City of Coral Gables Planning Department Staff Report

Subject: **Application No. 02-07-456-P. Change of Land Use, Rezoning and Site Plan Review.** St. Thomas Church/School proposes construction of a new athletic field on property immediately east of existing campus and modifications to the existing parking lots, more specifically as follows:

PROPOSED SITE PLAN

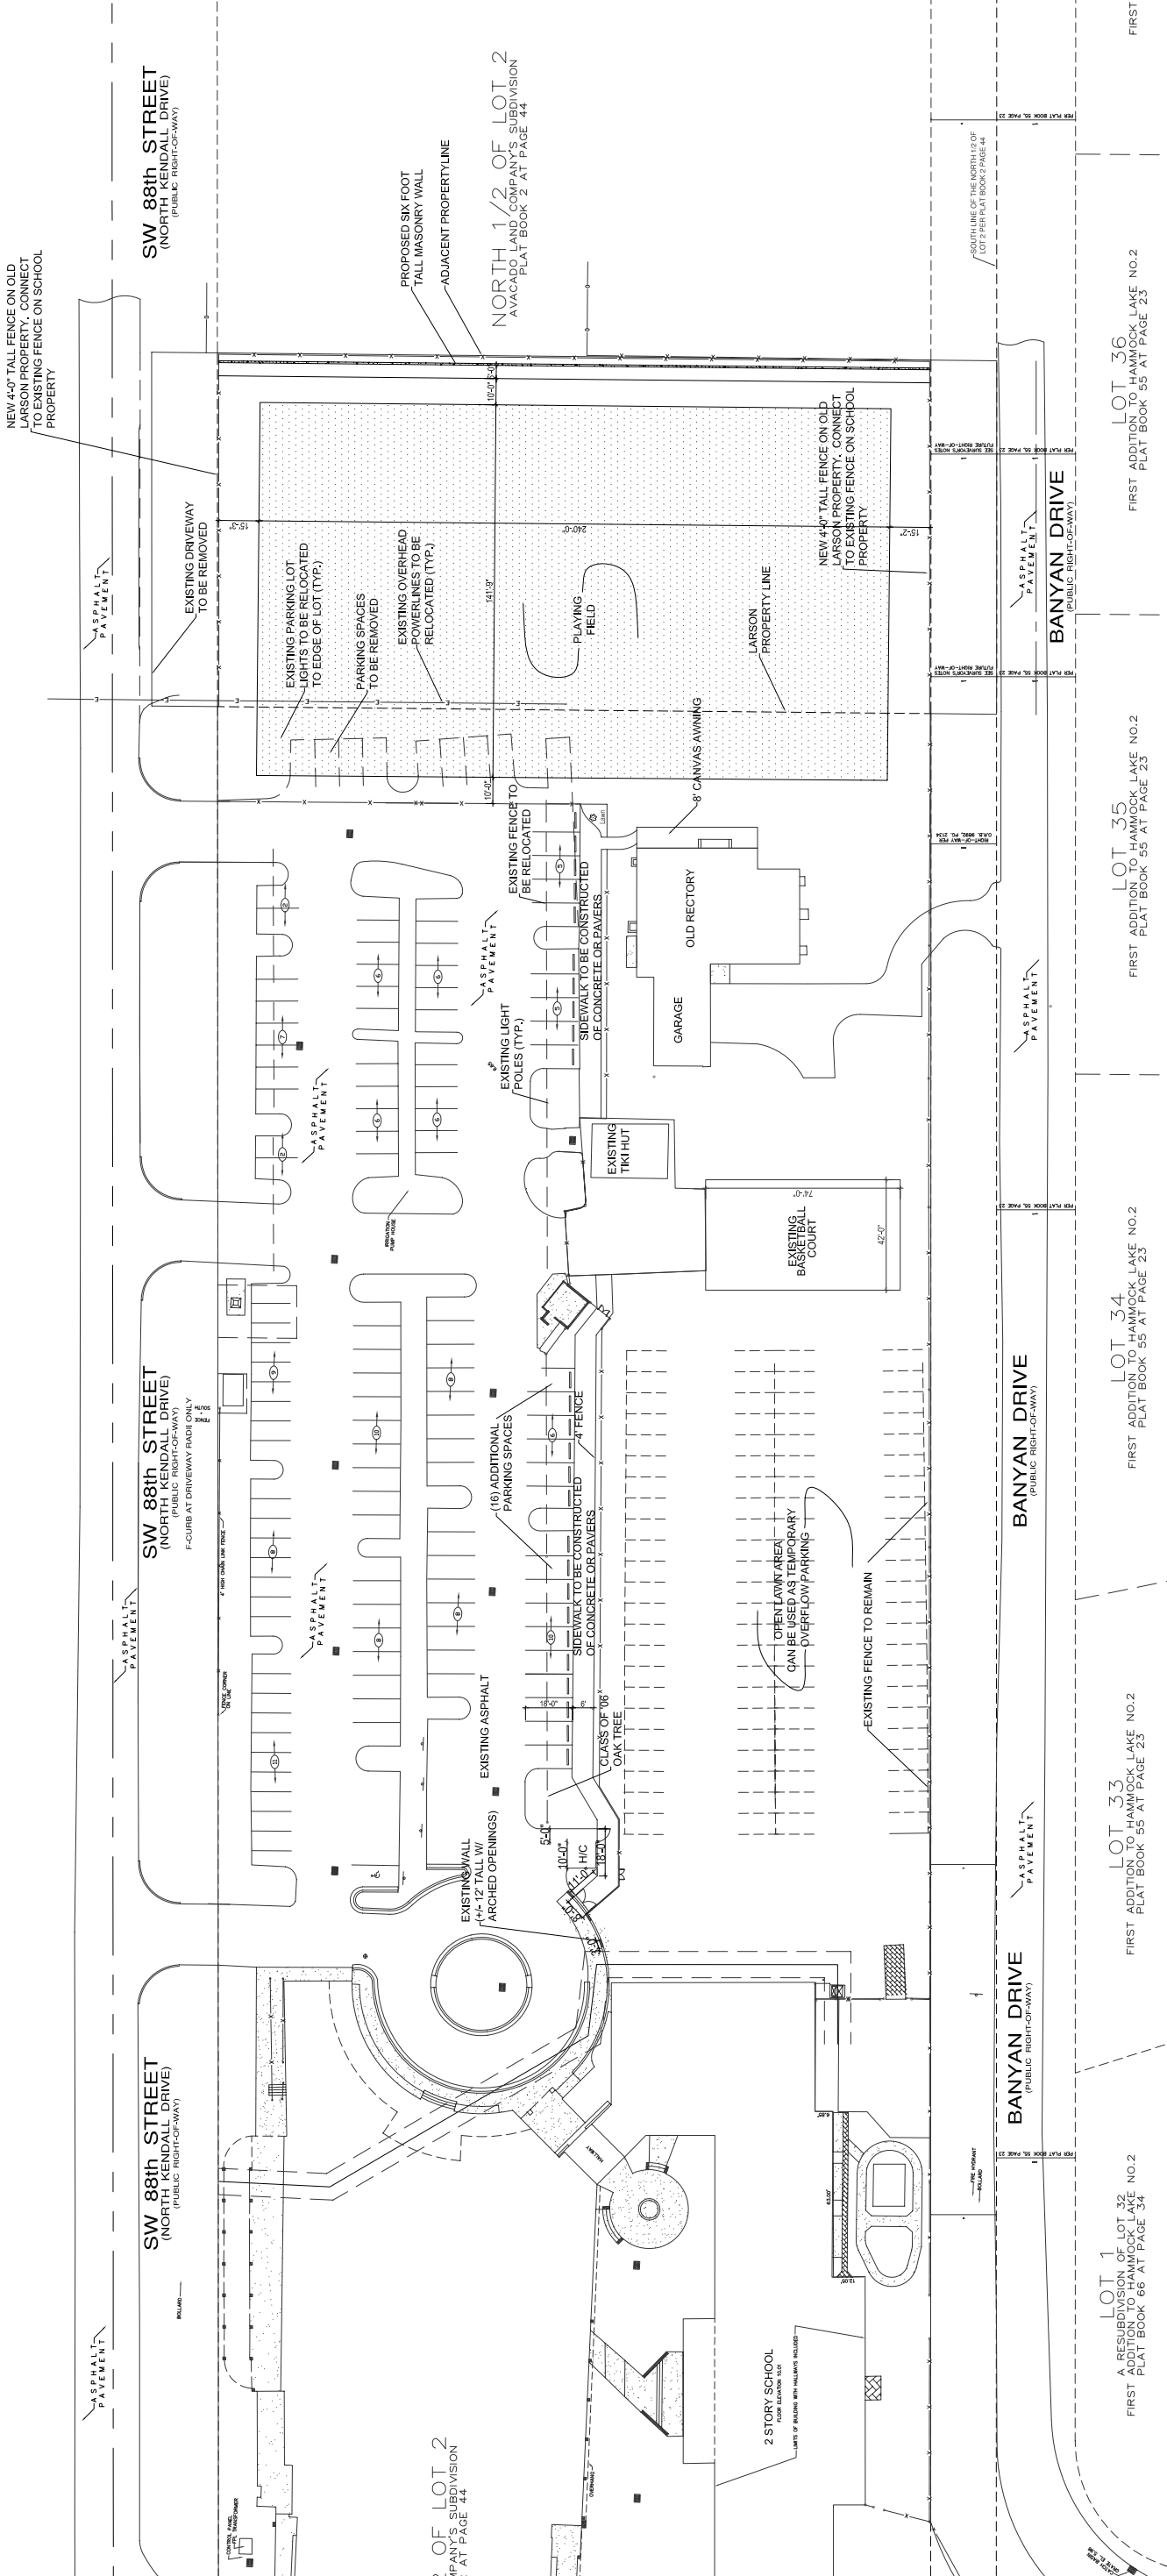
A Parking Compliance Letter was prepared and issued by the Building and Zoning Department on 08.25.08 evaluating on-site parking at St. Thomas Church (see Attachment B). In that letter, the Building and Zoning Department states that since no documentation is available to show the conditions of the property at the time of annexation into the City the existing 115 parking spaces are considered legally non-conforming. The proposal is to provide 123 parking spaces on-site, with the additional 8 spaces resulting from the reconfiguration of the parking lot. Since this proposal and previous approvals have not exceeded the minimum threshold requirements to require the property to be brought into compliance with the City's Zoning Code, no additional parking is required.

1. Application/supporting documentation. Construction of the project shall be in conformance with the following as amended pursuant to changes noted herein:

- a. Site plan prepared by Witkin Hults Design Group, dated 03.03.08.
 - b. Landscape plan prepared by Witkins Hults Design Group, dated 03.19.08.
 - c. Traffic circulation study prepared by David Plummer & Associates, dated 01.25.07.

PROPOSED LANDSCAPE AND BUFFER PLAN

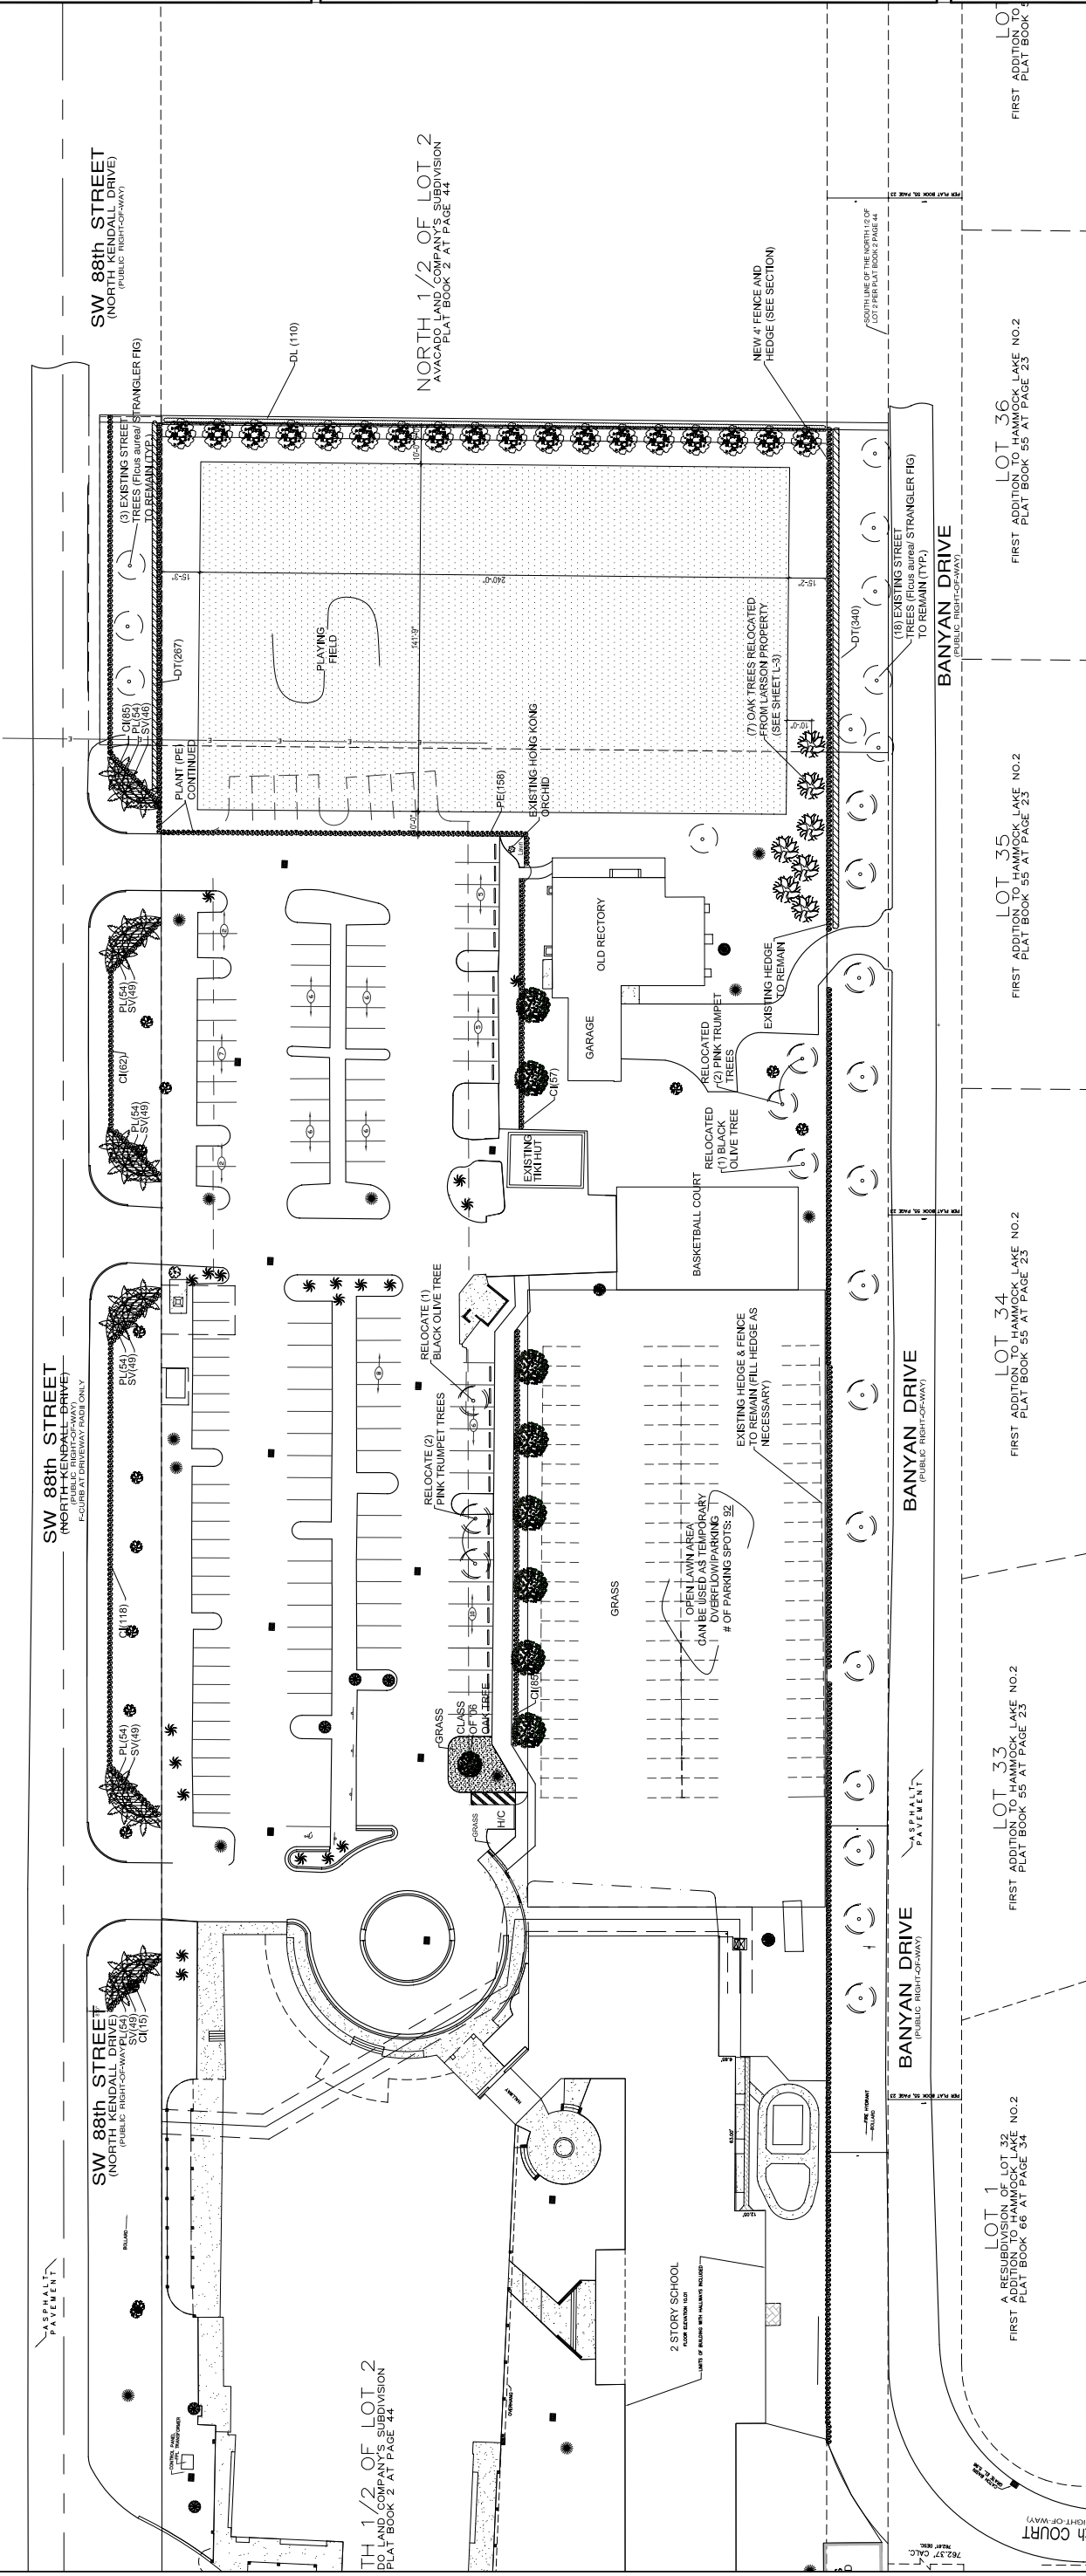
The landscape and site plan submitted with the application proposes a four and six foot high masonry wall along the east perimeter of the athletic field, and chain link fence along the north and south perimeter of the field. Low hedge materials are proposed to be planted along the inside of the perimeter wall/fences. A single row of Green Buttonwood trees would also be planted along the inside of the east perimeter wall. Staff has recommended a minimum ten (10) foot wide landscape buffer within a perpetual landscape easement which includes a continuous six (6) foot high masonry wall, hedge and understory plant materials as well as a continuous row of canopy trees. The installation of other landscape materials is proposed along both the north and south perimeter of the new athletic field to provide further buffering. In addition, numerous other operational and use restrictions has been placed upon the athletic fields to provide further mitigation of any potential negative impacts of the facility.

- a. Landscape buffer plan for the ten (10) foot easement on the entire eastern property line of the athletic field from North Kendall Drive to Banyan Drive to include as a minimum the following improvements:

1. Continuous six (6) foot high masonry wall on the property line; and,
 2. Continuous three (3) foot hedge/understory plant materials in front of the wall facing the athletic field; and,

3. Continuous row of twelve (12) to fourteen (14) feet Green Buttonwood overstory shade trees at a average of fifteen (15) feet on center facing the athletic field; and;

4. Irrigation.

PROPOSED PICK-UP/ DROP-OFF PLAN

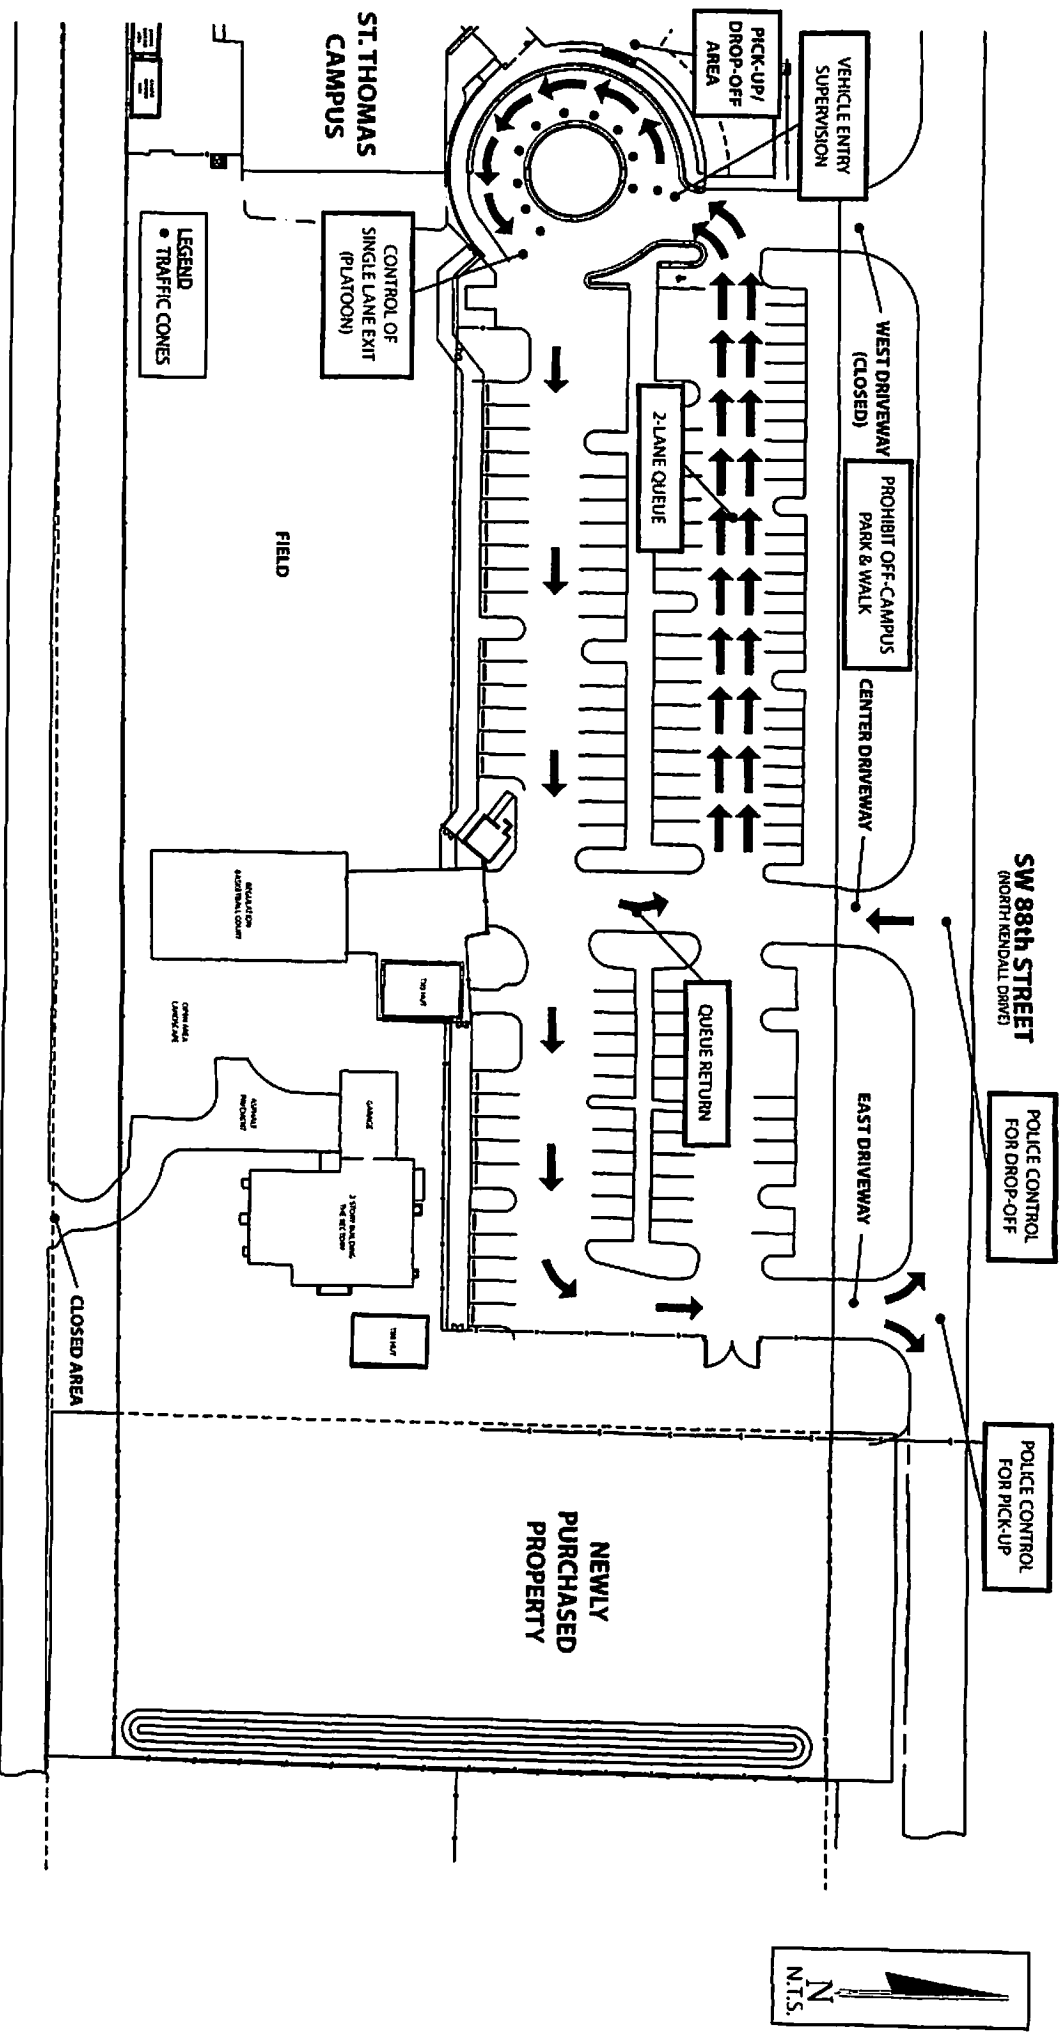
The applicant has submitted a pick-up / drop-off operations study for the school prepared by a traffic engineer. That study evaluates and provides recommendations for the improvement of the student pick-up / drop-off operations and ingress and egress to the site. Eleven (11) recommendations for improving the existing procedures are concluded and listed in the “St. Thomas Episcopal Parish School Pick-up/Drop-off Evaluation”. Planning Staff also met with the Police Department to review the current traffic operation patterns at the school. The Police Department stated that the current operational standards in place are adequate. However, the

- c. Traffic circulation improvements for school operations. As proffered by the applicant, within 180 days of City Commission approval, the below listed eleven (11) recommendations for improving the pick-up/drop-off operations for the school as concluded and listed in the “St. Thomas Episcopal Parish School Pick-

up/Drop-off Evaluation”, prepared by David Plummer & Associates, dated 01.25.07 shall be implemented:

- Do not allow off-campus parking/walking, especially on the swale area of North Kendall Drive.
 - Require all pick-up/drop-off to occur on the passenger side only.

- Do not allow parents to leave their vehicles unattended while in the pick-up/drop-off area. Parents who need to go on campus must park at designated areas.

- Allow only loading/unloading by “platoons” of vehicles in a single lane. Prohibit individual vehicles from exiting until the entire platoon is ready to exit. Control at the entry and exit points of the single lane loading areas is required.

- Do not allow children to exit or enter their vehicle from queue area.
 - If a student (or all students for multi-student vehicles) are not present for loading when the student’s vehicle reaches the loading point, the vehicle is required to exit the loading zone and rejoin the queue.
